DESIGN <i>CP</i>	DRAWN BY <i>CP</i>	DART AEROSPACE LTD HAWKESBURY, ONTARIO, CANADA	
CHECKED <i>[Signature]</i>	APPROVED <i>[Signature]</i>	DRAWING NO. DSI 9202	REV. A SHEET 1 OF 1
DATE 01.04.20		TITLE BASKET HINGE CHANGE	SCALE NTS
A	01.04.20	NEW ISSUE

DART SERVICE INSTRUCTION

TO AMEND INSTALLATION DRAWING D205-541 REV. D

AND INSTALLATION DRAWING D350-607 REV. E

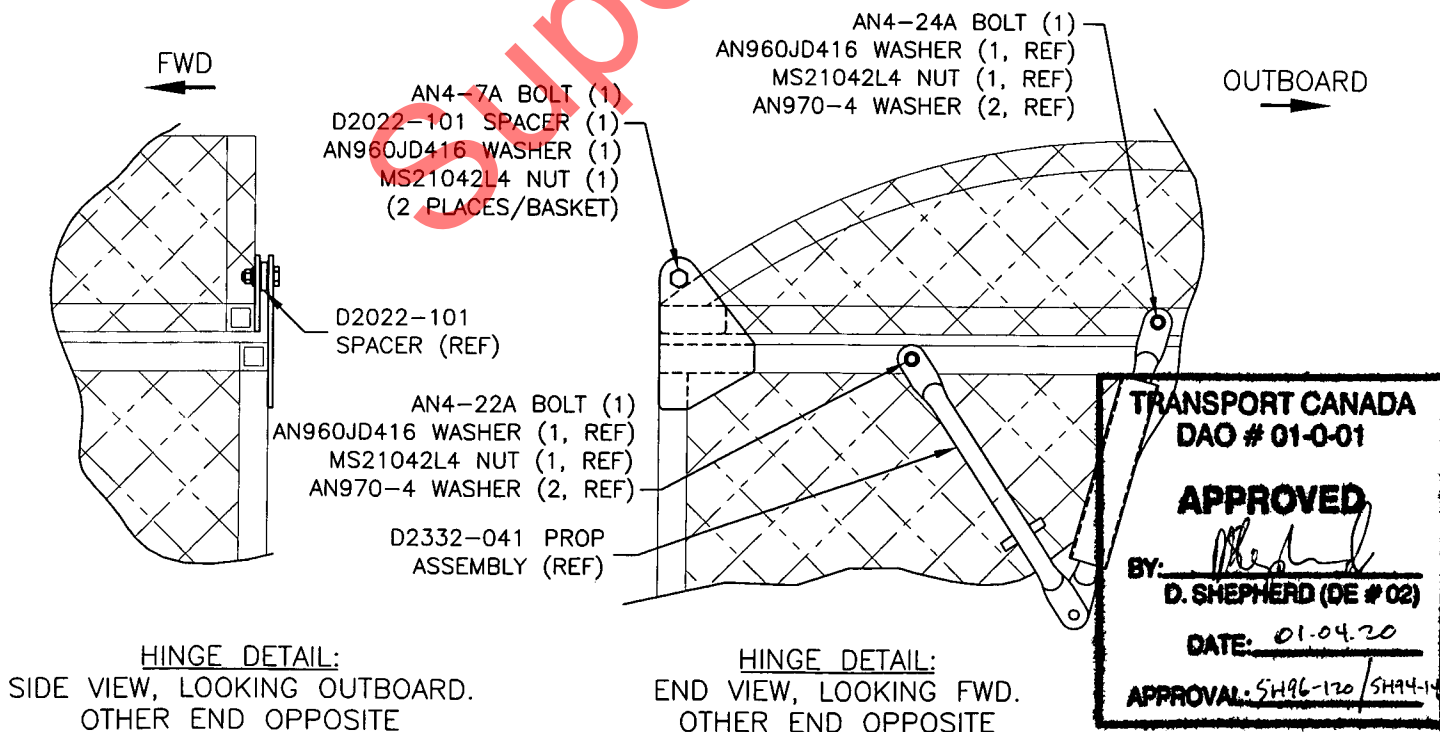
THE PARTS LIST OF D205-541 REV. D (205-541-041 CHG 004 OR LATER) / D350-607 REV. E (D350-607-041/-042 CHG 005 OR LATER) SHOULD BE AMENDED AS FOLLOWS:

REMOVE:

Qty	Part Number	Description
1	D2569	HINGE
36	AD64ABSLF	RIVET
1	AN4-22A	BOLT*

* NOTE: AN4-22A SUBSTITUTED FOR AN4-23A PER DSI 9159 REV. A ON D205-541-041

ADD:

Qty	Part Number	Description
2	D2022-101	SPACER
2	AN4-7A	BOLT
1	AN4-24A	BOLT
2	AN960JD416	WASHER
2	MS21042L4	NUT (OR MS21042-4)
